STATE OF CALIFORNIA
DEPARTMENT OF WATER RESOURCES
**OROVILLE DAM SAFETY
COMPREHENSIVE NEEDS ASSESSMENT**

Independent Review Board Memorandum #6

Oroville Independent Review Board Meeting No. 6
October 17-18, 2019

3. Does the IRB have any recommendations or comments on the Emergency Spillway erosion potential?

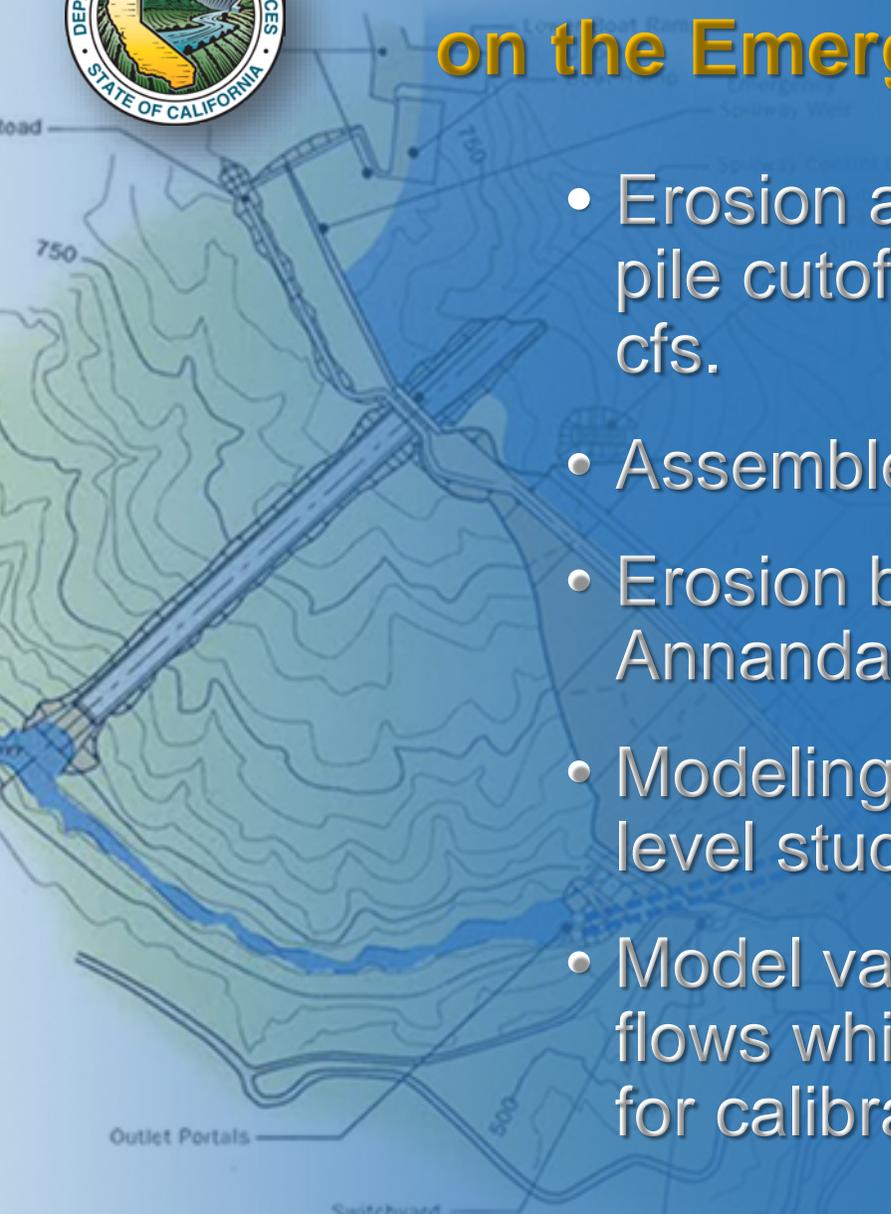
- Erosion analysis conducted downstream of the secant pile cutoff wall for flows between 6,000 cfs and 421,000 cfs.
- Assembled current knowledge of the geology of the area
- Erosion based on stream power as proposed by Annandale in 1995
- Modeling assumptions appear reasonable for a planning level study
- Model validated by running 2017 emergency spillway flows which yielded reasonable results without the need for calibration.

4. Does the IRB have any recommendations or comments on the updates for Tasks 1?

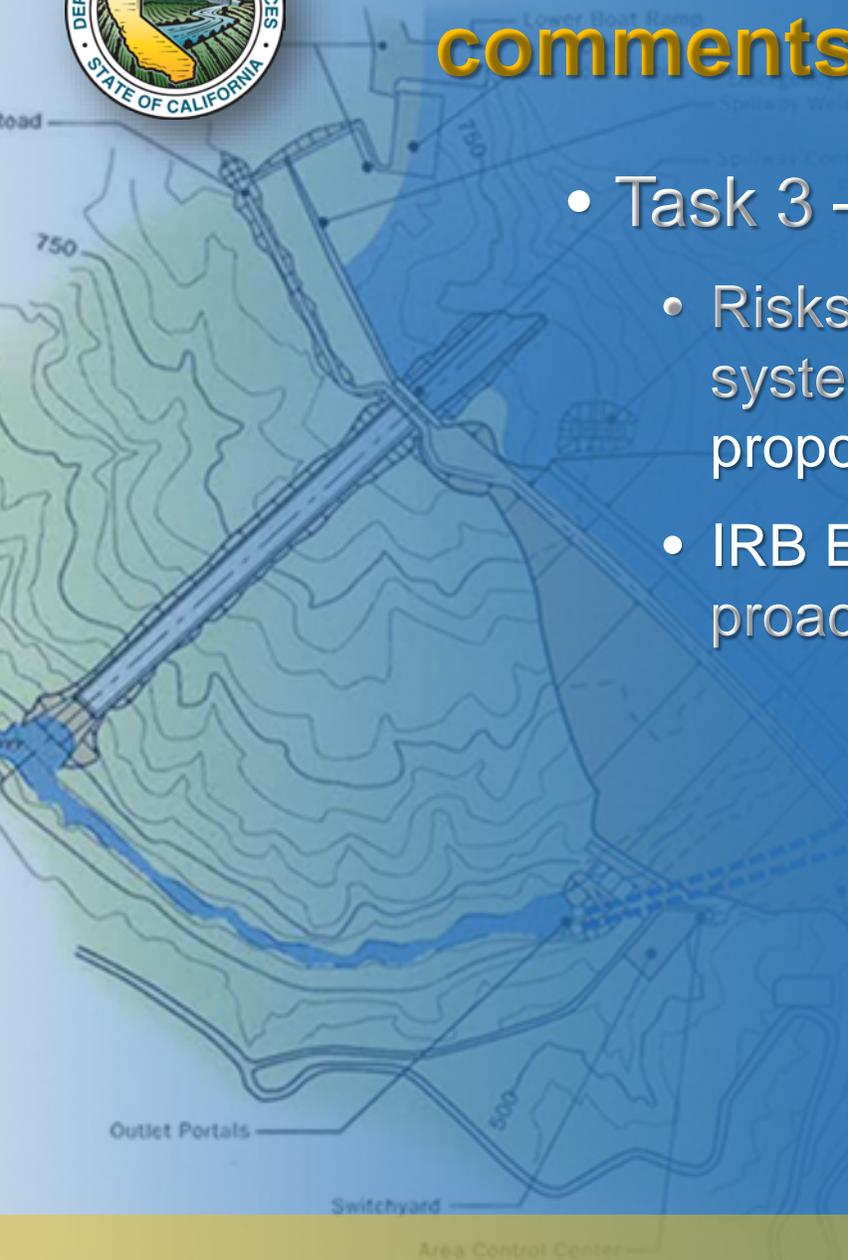
- Task 1 – Emergency Spillway
 - Two PFMs carried forward for developing mitigation measures:
 - Erosion of hillside materials creating tailwater impacts on Hyatt Powerplant
 - Scour downstream of the secant pile cutoff leading to undermining of the secant pile wall, apron, and concrete monoliths.
 - 50 Conceptual measures considered
 - 9 Measures survived the screening process to become “recommended measures”

4. Does the IRB have any recommendations or comments on the updates for Tasks 4?

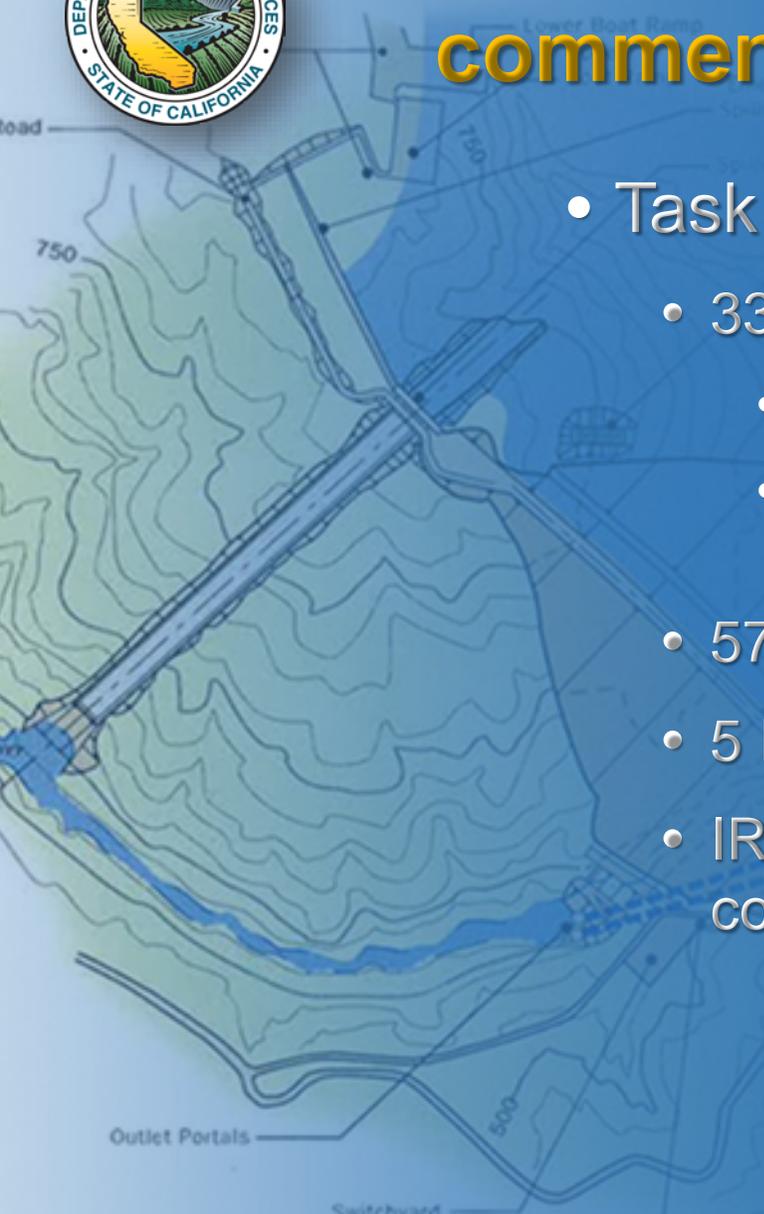
- Task 4 – Low Level Outlet
 - 33 PFMs developed with primary risks in:
 - Rock anchors of Hyatt Power plant
 - Slope instability above the Palermo Tunnel inlet, Hyatt Switchyard, Area Control Center Building and the Hyatt Access Portal
 - 57 Potential mitigation measures considered
 - 5 Recommended measures
 - IRB recommends consideration of an additional measure consisting of a dual-purpose single low level outlet.

4. Does the IRB have any recommendations or comments on the updates for Task 5?

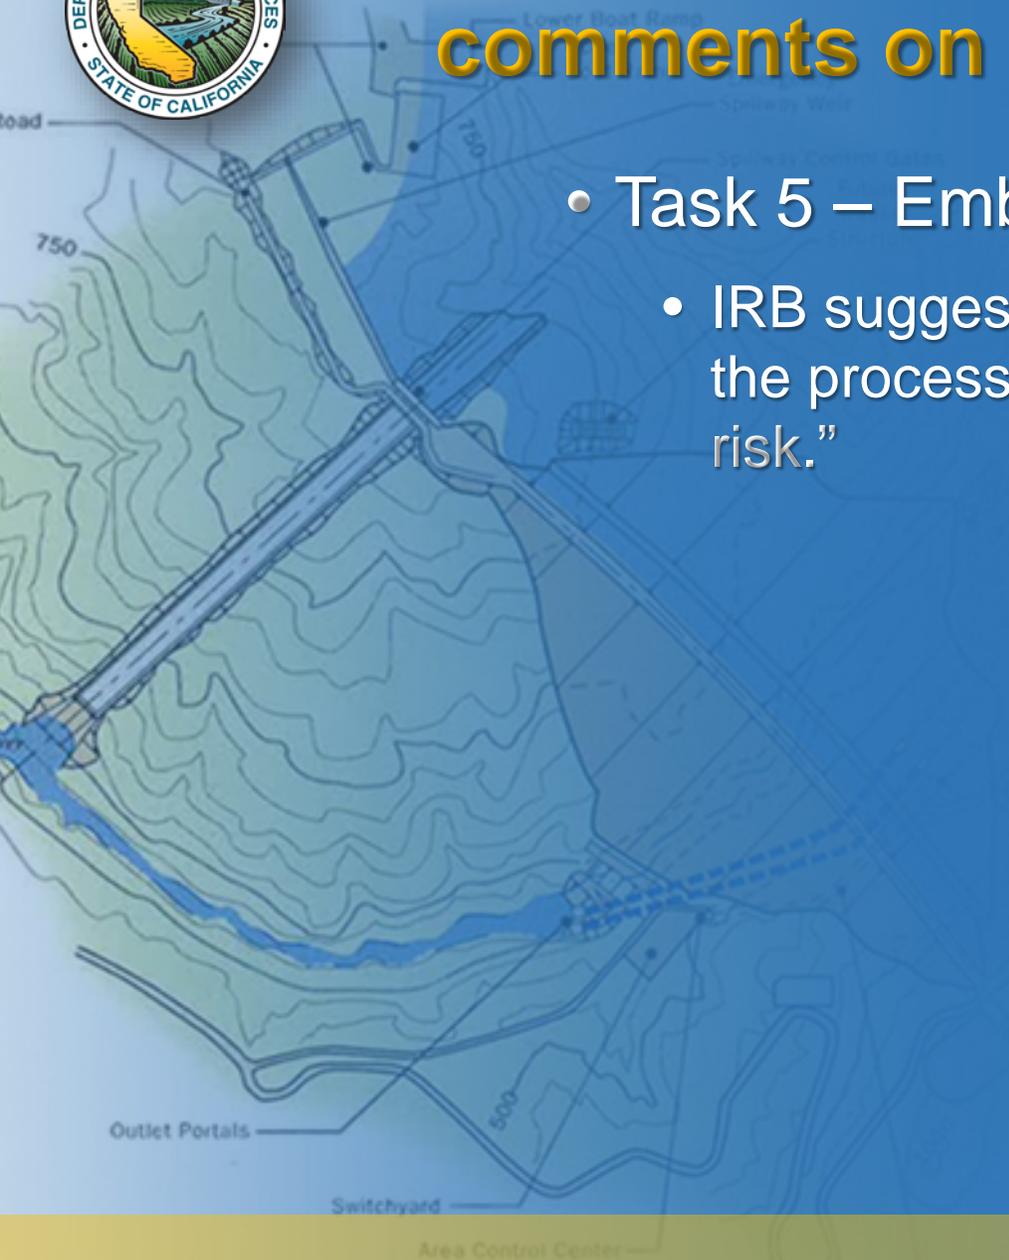
- Task 5 – Embankments
 - IRB suggests that the team provide additional information for the process used to identify selected PFMs as being “highest risk.”
